Addendum: **2**

Date: **5/13/2025**

Project: **FWCS HPB Natatorium HVAC Improvements**

Comm #: **24634**

Item #8: Drawing Sheet E401, "Electrical Details and Schedules"

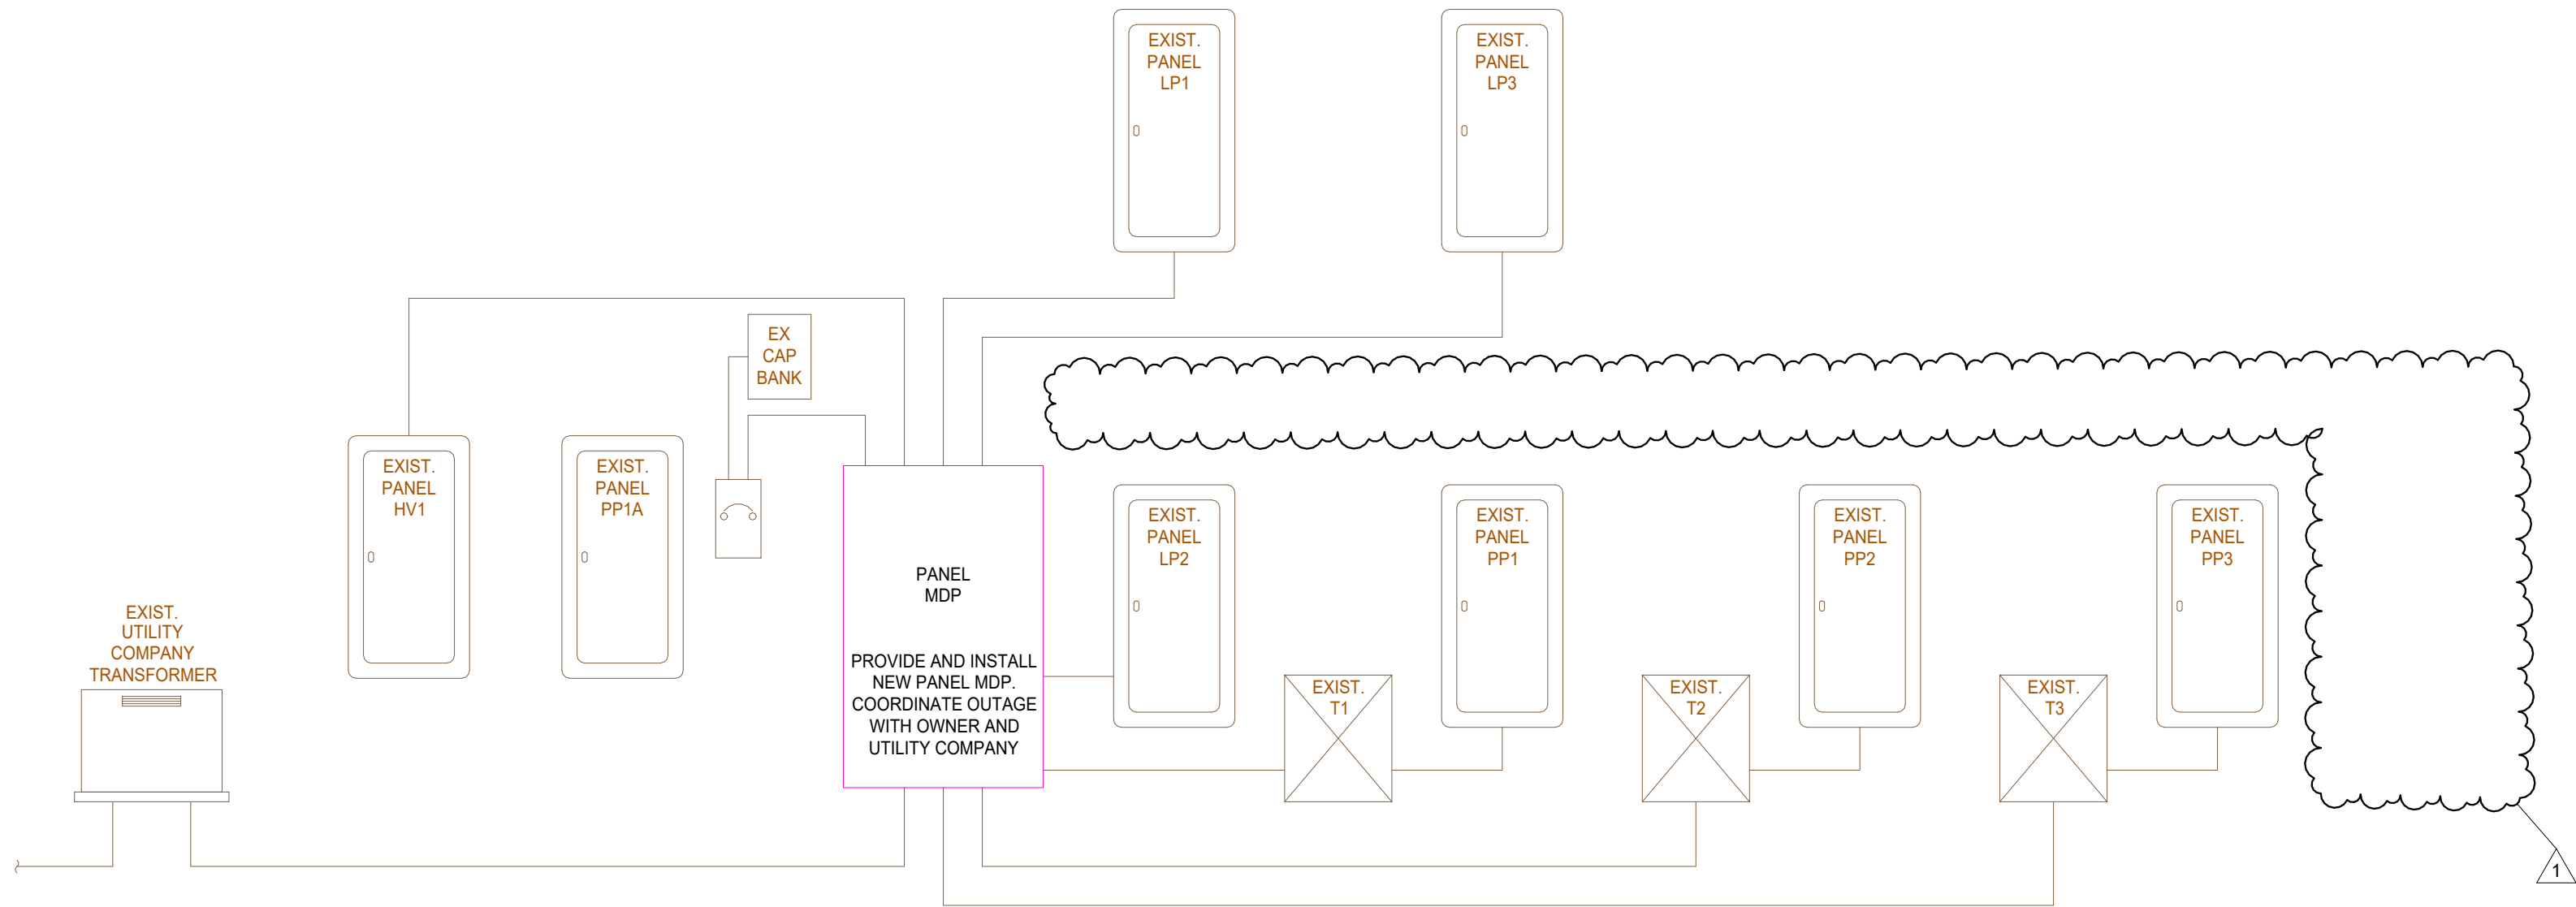
- A.** See revised circuit information for AHU-1 and ACCU-1 in revised Equipment Schedule and Panel Schedules on attached revised sheet E401 dated 5-13-2025.
